ADDENDUM NO. 2

TO: ALL BIDDERS
PROJECT: ITB PW 37-19 – FOY SHAW PARKWAY
BID TIME AND DATE: 03:00 PM (CST), September 4, 2019 (NO CHANGE)

August 27, 2019

FOY SHAW PARKWAY FROM US 90 TO JOHN GIVENS ROAD FINANCIAL PROJECT ID 425617-2-94-01

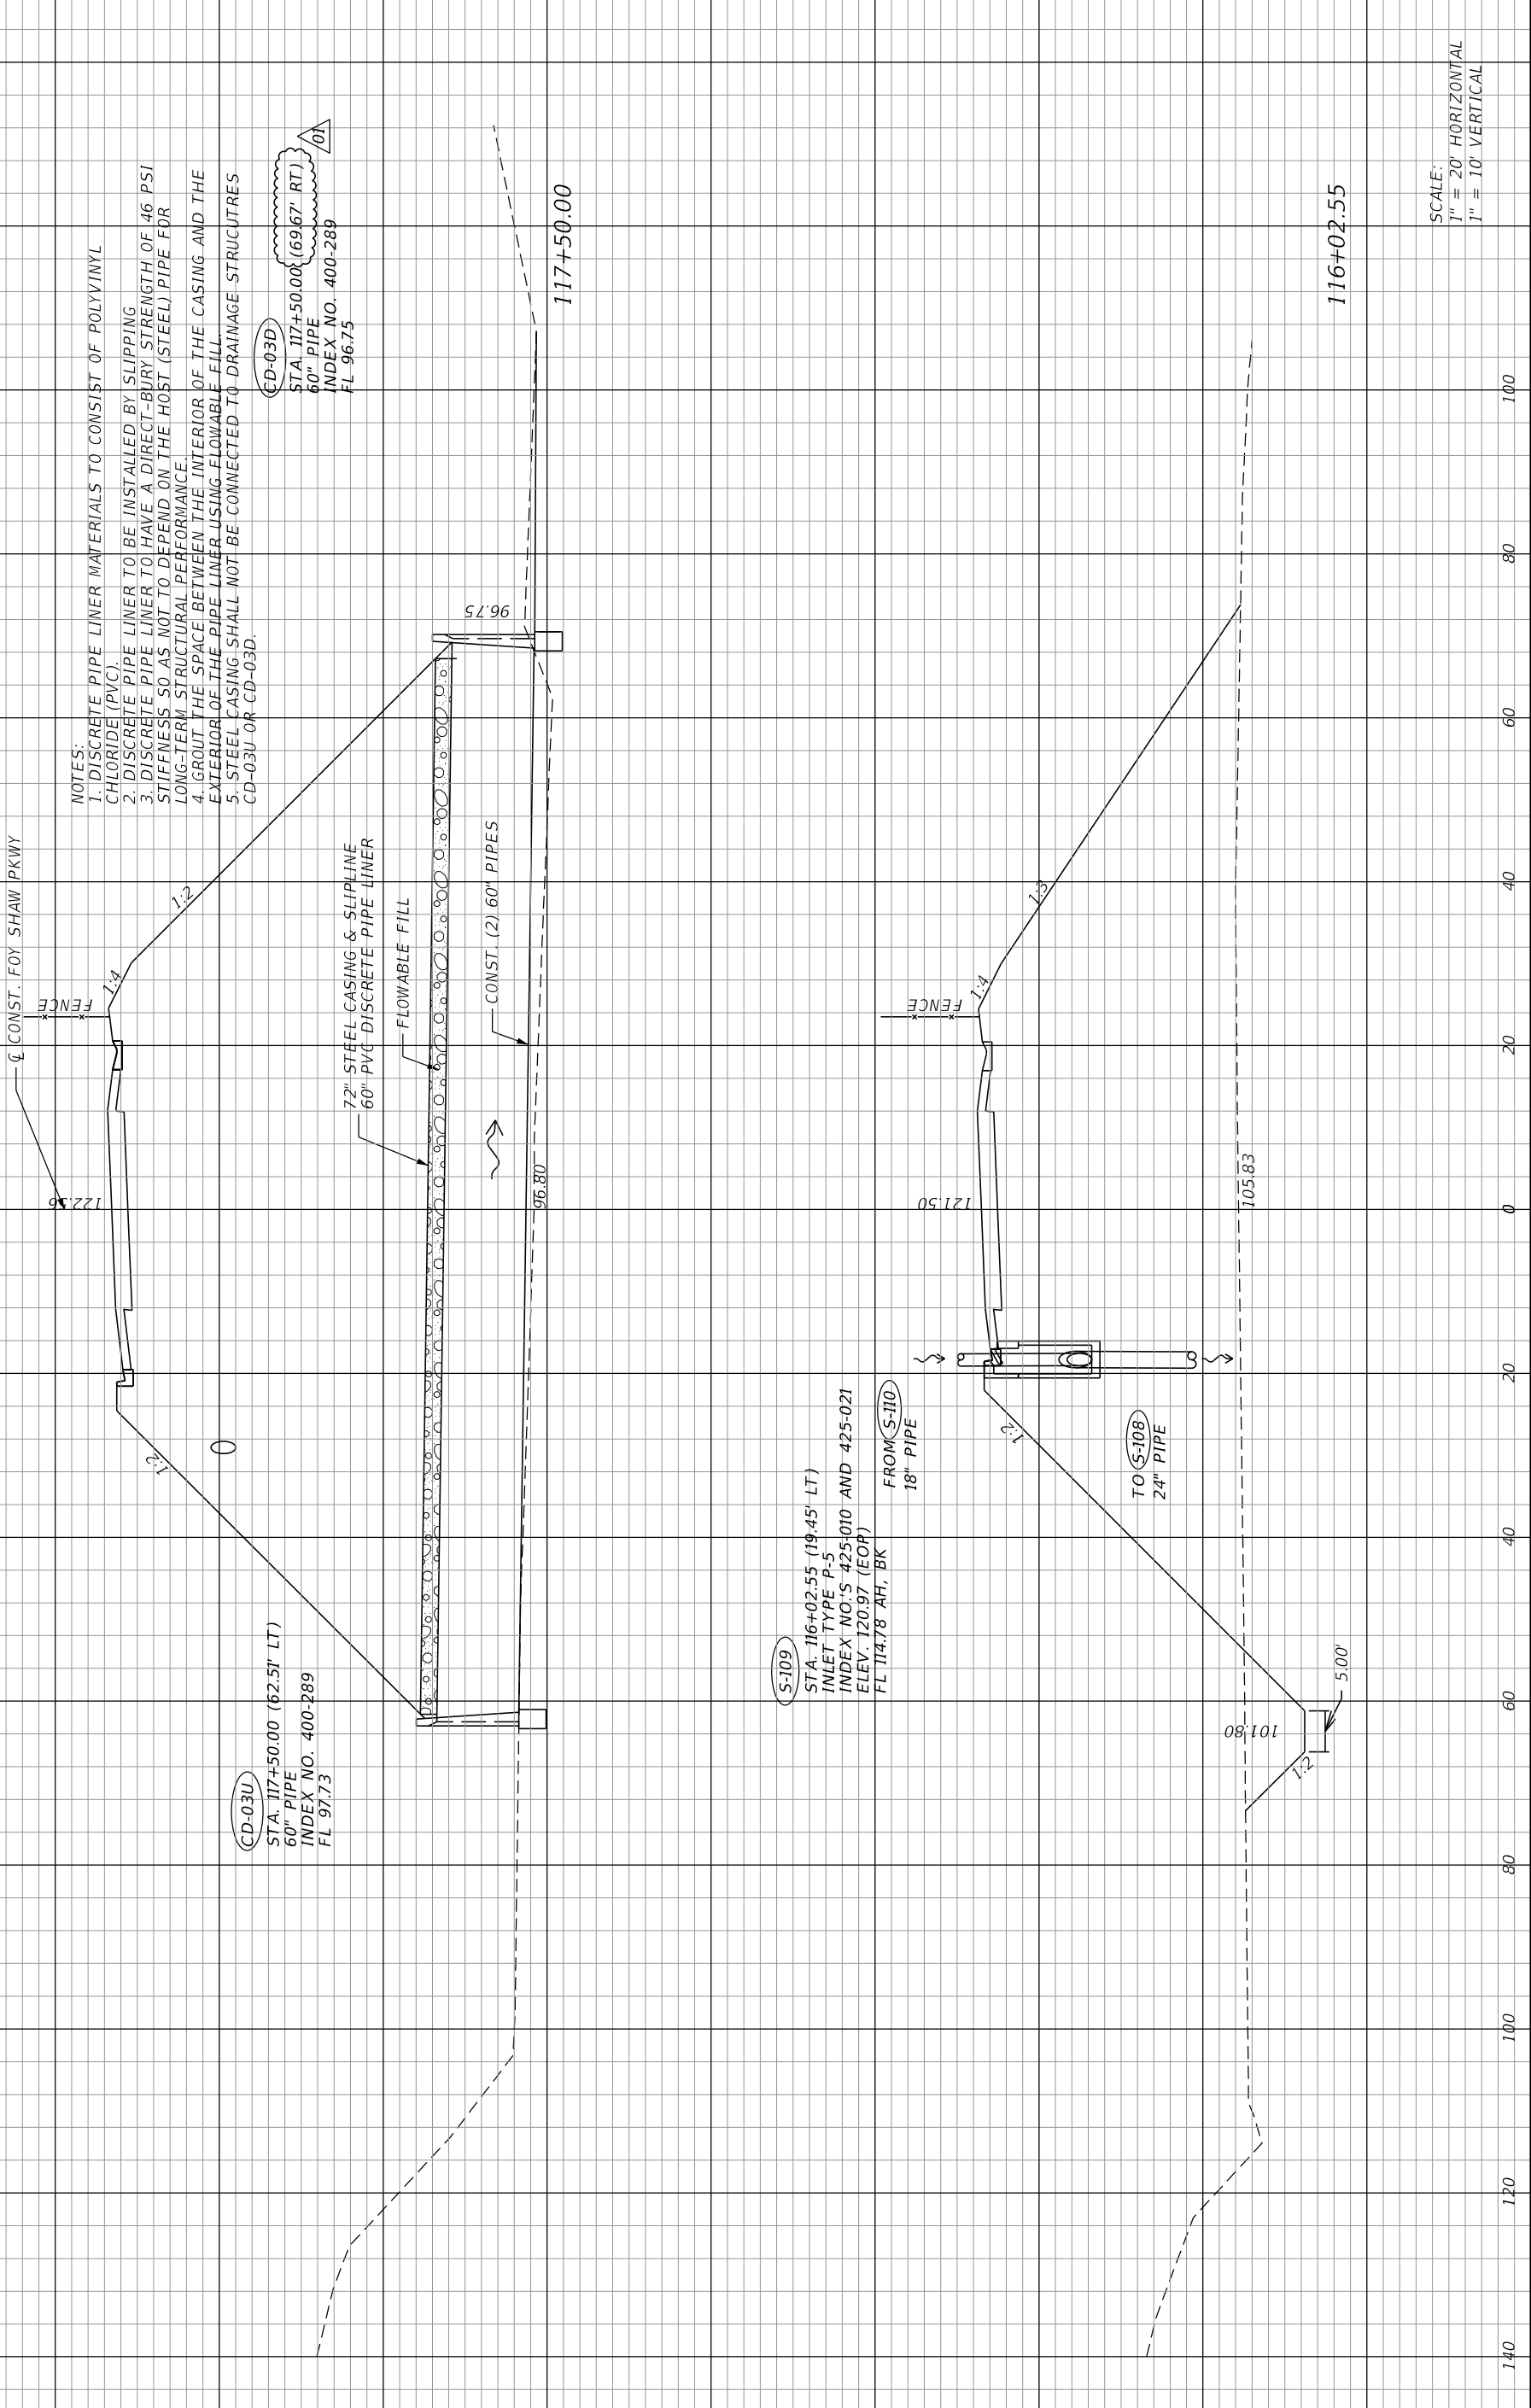
DATE	DESCRIPTION	REVISIONS
8/22/19	UPDATED STRUCTURE OFFSET	
	Addendum No. 2
